Access Compliance Report

Public Rights-of-Way

Intersection ID: 4122	Main Street: DAVID_COX_RD	Cross Street: MALLARD_RIDGE_DR	Location: NE
ADA ID: BE68D1D83C19	Ramp Type: PerpDiag	Initial Pass/Fail: Fail	Overall Compliance: No
		Severity Score: 35

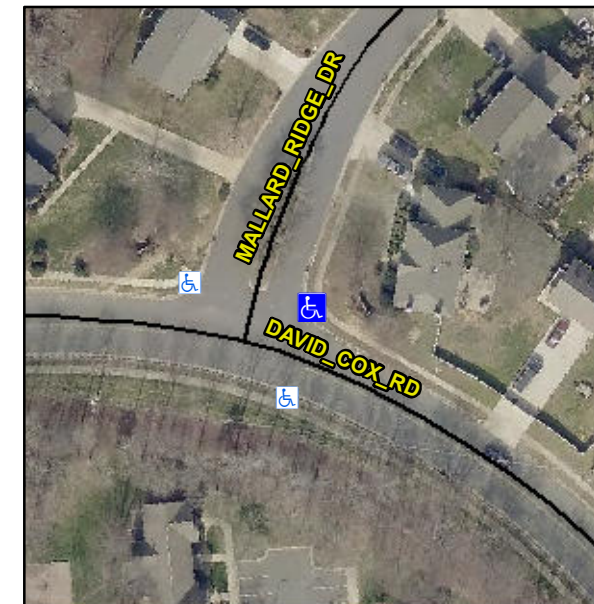
Not Found, R304.5.1, R304.2.2, R304.5.3

Compliance	Description	Data	Compliance	Description	Data
N/A	Ramp Length (in)	50.0	No	Ramp Slope (%)	14.2
No	Ramp Width (in)	40.0	No	Ramp XSlope (%)	3.4
N/A	Flare Type LT	N/A	N/A	Flare Type RT	N/A
N/A	Flare Slope LT (%)	N/A	N/A	Flare Slope RT (%)	N/A
N/A	Flare Traversable LT?	N/A	N/A	Flare Traversable RT?	N/A
N/A	Landing Length (in)	N/A	N/A	DWS Provided?	N/A
N/A	Landing Width (in)	N/A	N/A	DWS Contrast?	N/A
N/A	Landing Slope (%)	N/A	N/A	DWS Length (in)	N/A
N/A	Landing X Slope (%)	N/A	N/A	DWS Full Width?	N/A
N/A	Landing Curb? (Y/N)	N/A	N/A	DWS Offset (in)	N/A
N/A	Shared Landing?	N/A			
N/A	Gutter Ponding?	N/A	N/A	Gutter Slope (%)	N/A
N/A	Gutter Lip Ht (in)	N/A	N/A	Gutter X Slope (%)	N/A
N/A	Painted X Walk1?	No	N/A	Painted X Walk2?	No
	X Walk 1 Direction	To W		X Walk 2 Direction	To S
N/A	X Walk 1 Width (in)	N/A	N/A	X Walk 2 Width (in)	N/A
	X Walk 1 Slope (%)	5.4		X Walk 2 Slope (%)	1.9
	X Walk 1 X Slope (%)	1.3		X Walk 2 X Slope (%)	2.9

Remove & Replace Curb Ramp With Two New Directional Ramps or Equivalent.
